AGENDA

ST. TAMMANY PARISH PLANNING COMMISSION MEETING 6:00PM – TUESDAY, JUNE 11, 2019 ST. TAMMANY PARISH GOVERNMENT COMPLEX PARISH COUNCIL CHAMBERS

ENTERING THE TAMMANY TRACE STAFF ANALYSIS REPORT (As of June 4, 2019)

CASE NO.: TRC19-05-001

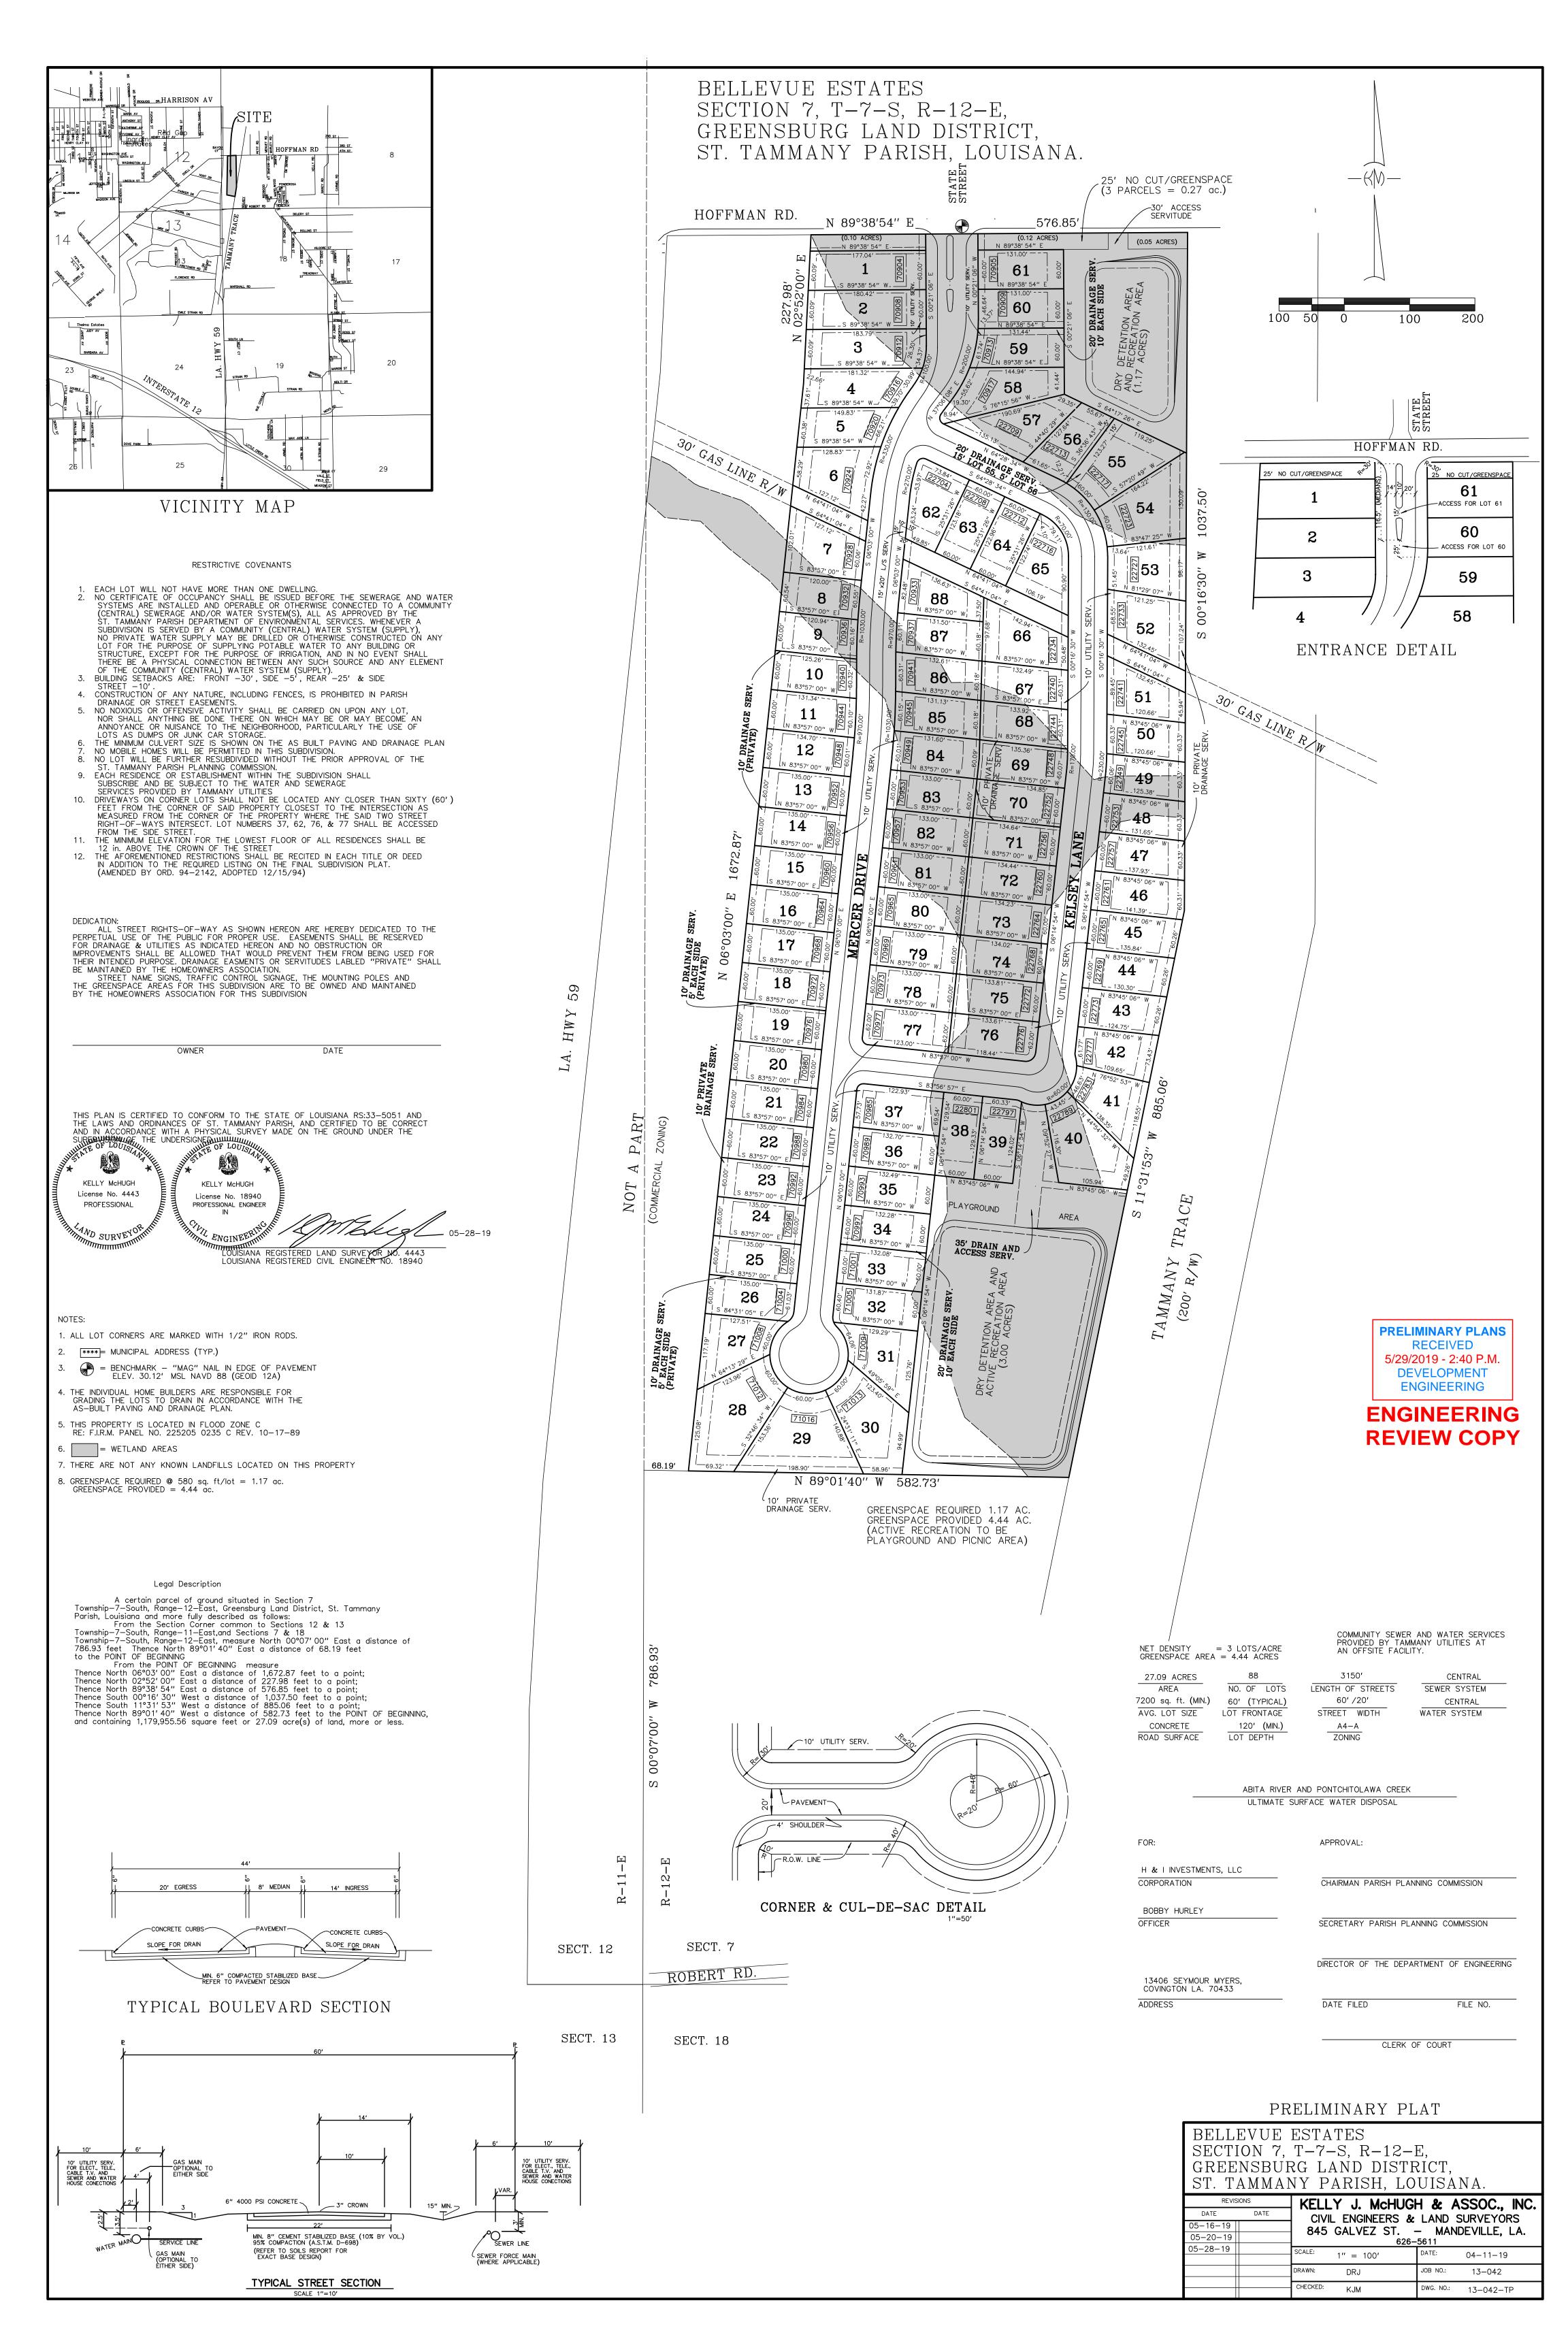
- 1. Approval for crossing the gas line right-of-way with a roadway has not been received from the gas line company.
- 2. A revised Traffic Impact Analysis for this development has not been received and approved by St. Tammany Parish.
- 3. Approval from Gravity Drainage District #5 is required.

- 4. The dedication statement for Bellevue Estates calls for parish maintained drainage. All drainage servitudes need to meet St. Tammany Parish Public Works standards. Revise all servitudes and update plans.
- 5. Sewer lift station servitude shown needs to relocated out of the road right-of-way to avoid conflicts with the required roadside ditches.

- 6. The inverts shown for the proposed culvert along Hoffman Road will require modifications to the existing ditch. Include proposed modifications to the ditch or clarify.

- 7. Provide cross-section showing minimum ditch size required between Lots #68 and #69.
- 8. Existing ground elevations at southeast corner of Lot 40 are lower to the south and to the east than the proposed ditch invert to the west. Additionally, the provided section for this swale specifies 0.5' to 1.0' depth but this turn near the lower end of this swale is only 0.3' deep. Revise proposed inverts or provide detail showing how water from swale along east property line will be directed into pond and not into property to the east.

- 9. Existing ground elevations at southwest corner of Lot 28 are lower to the south and to the west than the proposed swale invert. Revise proposed invert(s) or provide detail showing how water will be directed into pond and not into property to the west.

- 10. Provide cross-sections of the proposed Tammany Trace improvements every 300' starting at south pond outfall extending to limits of work.
- 11. Even though the rate of runoff from the overall parcel will be reduced, it will be collected and discharged at a point location in lieu of a distributed area flow. Confirm the existing ditch and culverts have capacity to handle the discharge from the pond outfall in addition to the existing drainage requirements. Also, add dimension and material of existing drainage structure.

12. Proposed elevations for the east gas line crossing conflict with the required minimum clearance. Revise.

- 13. Provide written approval from Tammany Utilities for the proposed water and sewer plans.
- 14. Provide written verification from Tammany Utilities that water and sewer capacity is available for this development through the existing water and sewer systems.
- 15. Provide written verification from Tammany Utilities that the existing 8" line and sewer lift station can accept the additional capacity from the 4" sewer force main.

16. Ultimate Disposal Map shows north pond draining through cross culvert at outfall and into a ditch north to the Abita River; however, this ditch appears to drain towards the roadside ditch and not continue to the Abita River. Provide elevations showing direction of drainage flow and verification that this ditch extends to the Abita River as indicated on the submitted Ultimate Disposal Map.

- 17. Clarify how the post development sheet flow is 220' and the pre-development sheet flow is only 100' for the south sub-catchment.
- 18. Clarify how the post development sheet flow is 170' and the pre-development sheet flow is only 100' for the north sub-catchment.
- 19. Pre-development conditions on this site appear to be dense woods instead of light underbrush woods. Revise or clarify.

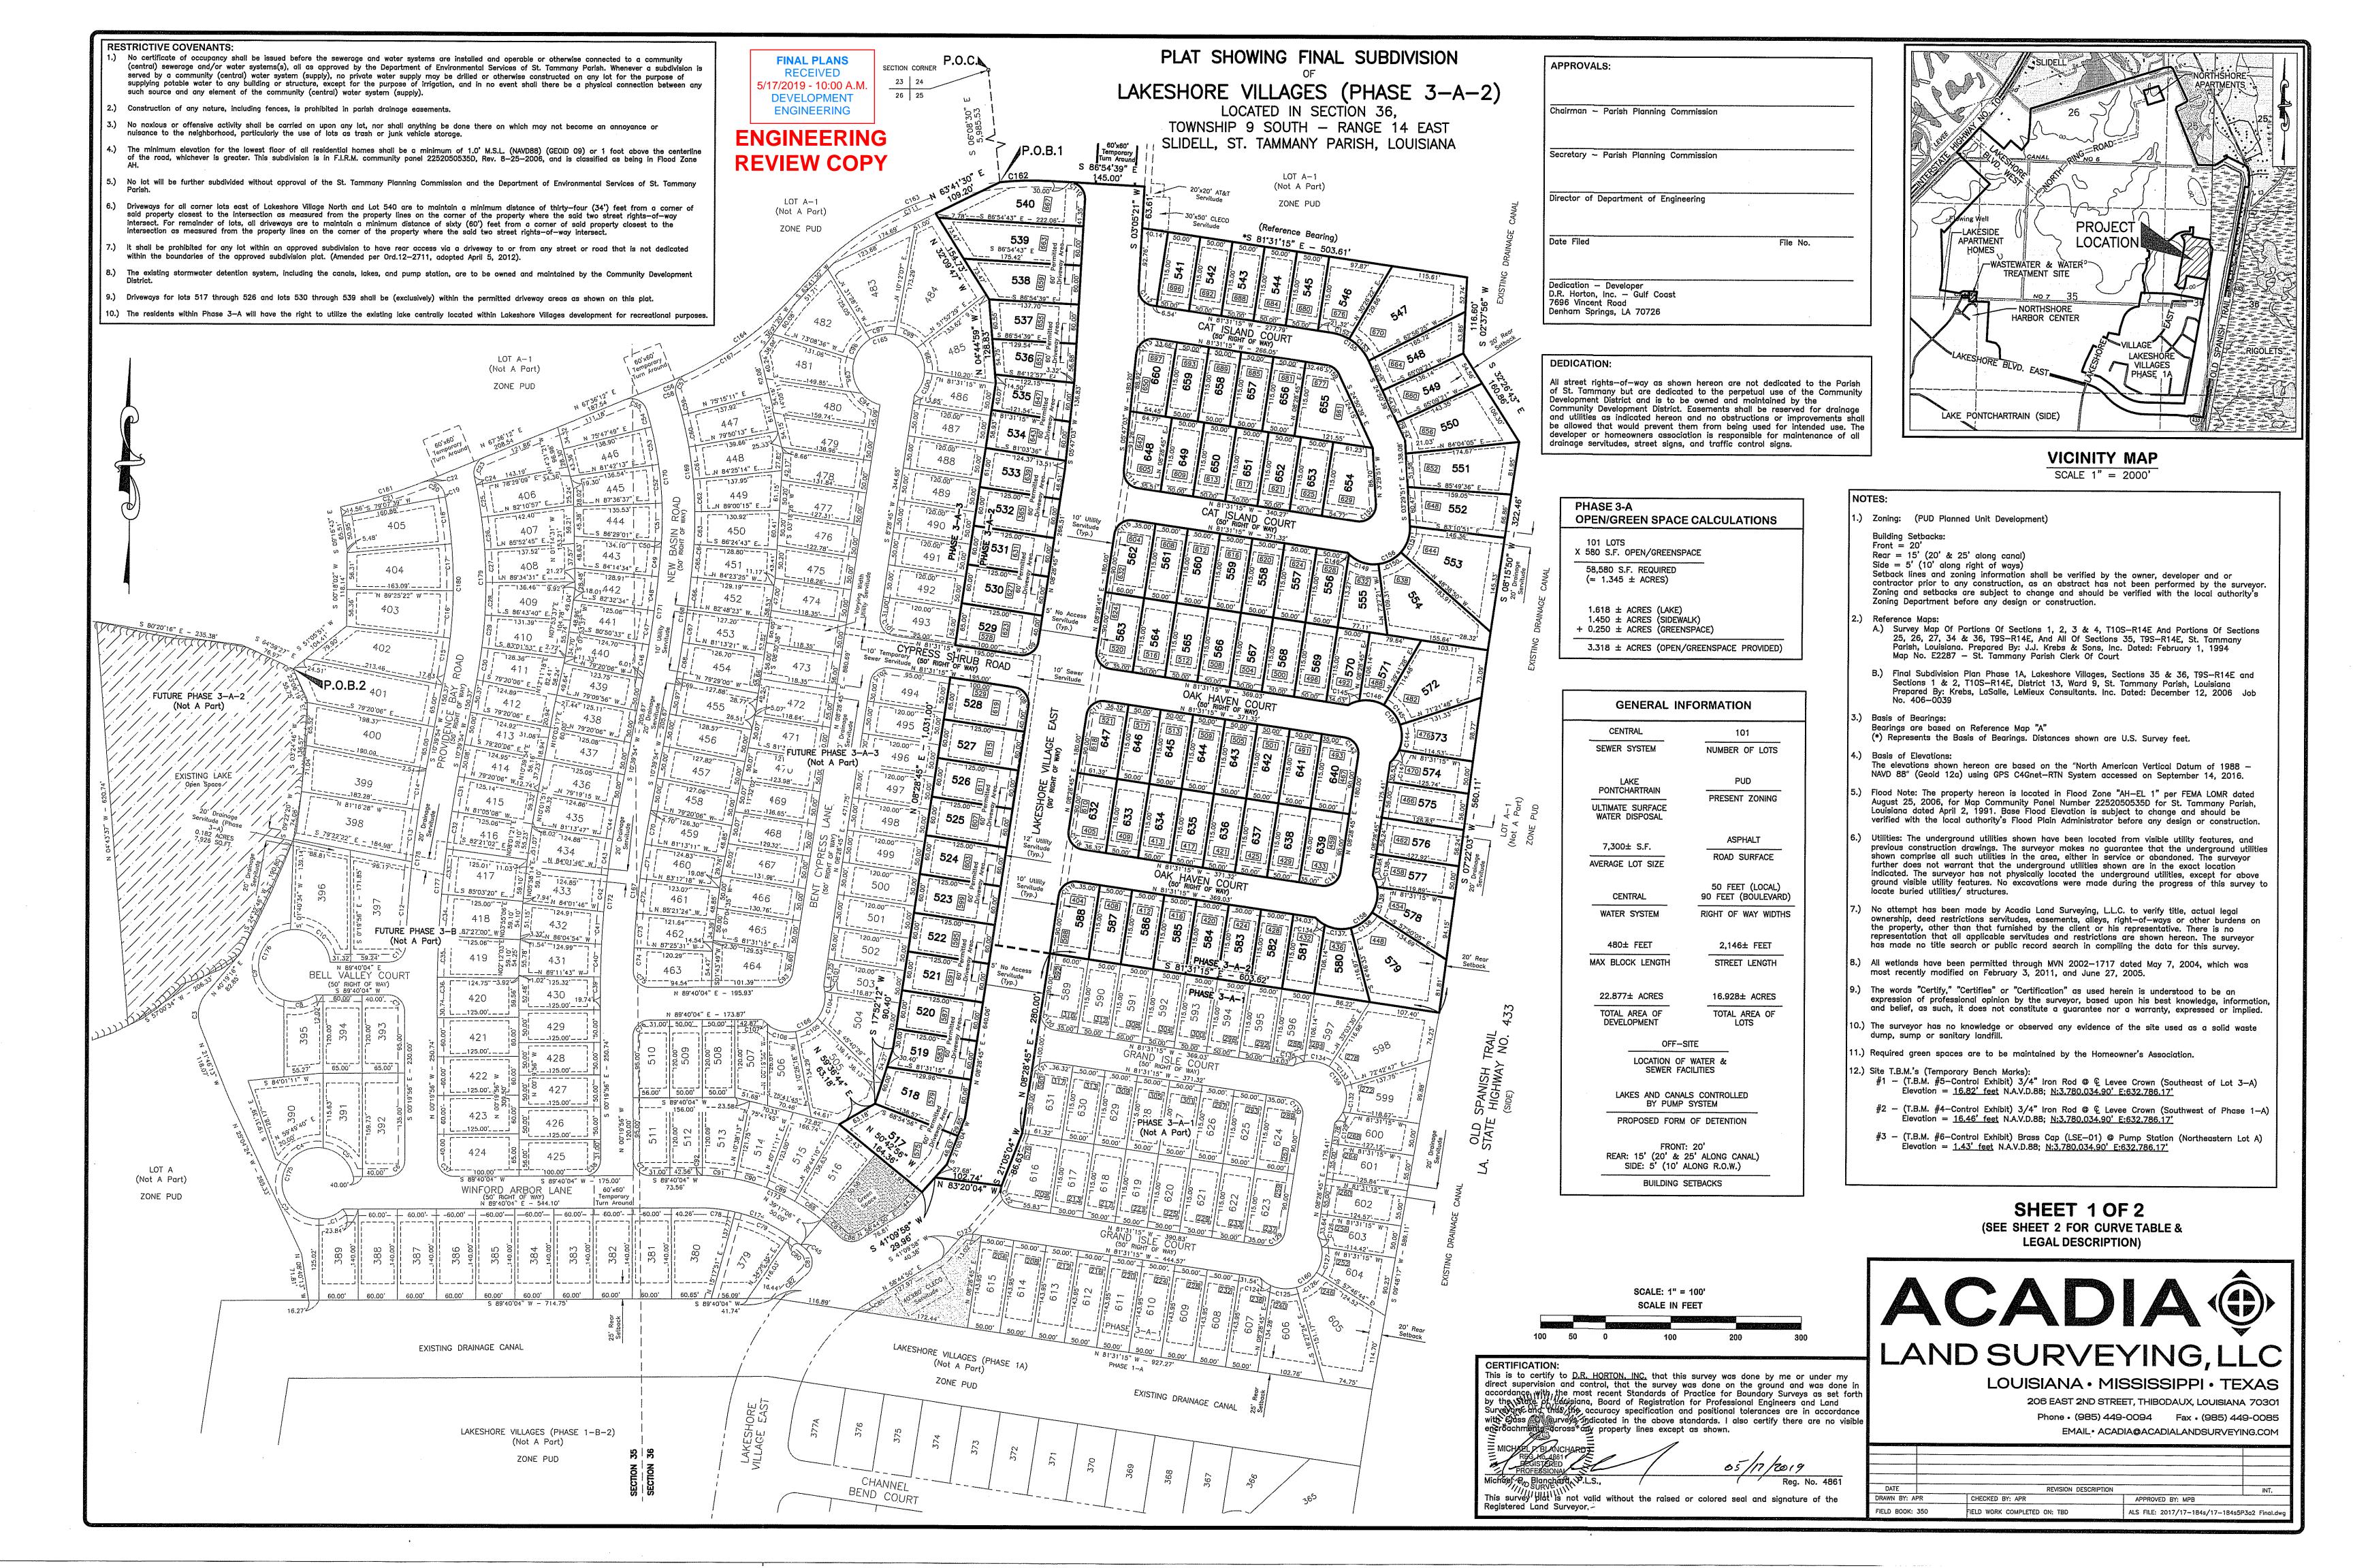
- 1. Provide asphalt core test results for Oak Haven Court and Cat Island Court.
- 2. Update lab testing report #1821 to provide the location of where the testing was performed.
- 3. Provide proctor dry density test results for Cat Island Court.
- 4. Provide utility trench and backfill test results.
- 5. Blue reflectors need to be installed in the proximity of all fire hydrants.

- 6. Lot #532's address needs to be corrected to read 635 instead of 365.
- 7. Revise the greenspace calculations to reflect Phase 3-A-2 instead of all of Phase 3-A.
- 8. Add a signature line for the Clerk of Court on both pages of the Final Plat.
- 9. Remove "Future Phase 3-A-2" call-outs from this plat.
- 10. Revise Restrictive Covenant #6 to state "Lakeshore Village East" not "Lakeshore Village North".
- 11. Revise the subdivision boundaries and legal description to include the greenspace parcel located to the south of Lot # 517.

- 12. Provide as-built elevations for all newly constructed roadways within Phase 3-A-2.
- 13. Drainage structure 5 to structure 7 elevations do not provide positive flow. Verify invert elevations are correct for these structures.
- 14. Drainage structure 19 to structure 23 elevations do not provide positive flow. Verify invert elevations are correct for these structures.
- 15. Drainage structure 56 to structure 58 elevations do not provide positive flow. Verify invert elevations are correct for these structures.
- 16. A stub out of Cypress Shrub Road within Phase 3-A-2 needs to be paved and the as-built elevations need to be provided for the drainage structures.

17. Provide a water and sewer system capacity letter verifying that the existing system has capacity to service this phase of Lakeshore Villages.

- 18. Provide a written update on when the sewer force main and water line improvements along Lakeshore Village East to the Oak Harbor East Utility site approved under Phase 3 of this development are scheduled to be completed.
- 19. The gravity sewer line between sewer manhole #5 and manhole #7 does not meet the recommended minimum slope. Verify the constructed slope is sufficient to achieve a clearing velocity of 5 ft/s.

- 20. The previously approved preliminary plans called for cross walk striping and yield to pedestrian signage that is not reflected on the as-built plans or constructed in the field. Install all signage and striping in accordance with the approved plans and update the as-built plans to reflect these improvements.
- 21. The street name sign at the intersection of Lakeshore Village East and Cypress Shrub Road needs to be installed.
- 22. The street name sign at the intersection of Lakeshore Village East and Oak Haven Court needs to be installed.
- 23. The speed limit sign to the south of the Lakeshore Village East and Oak Have Court intersection needs to be installed.
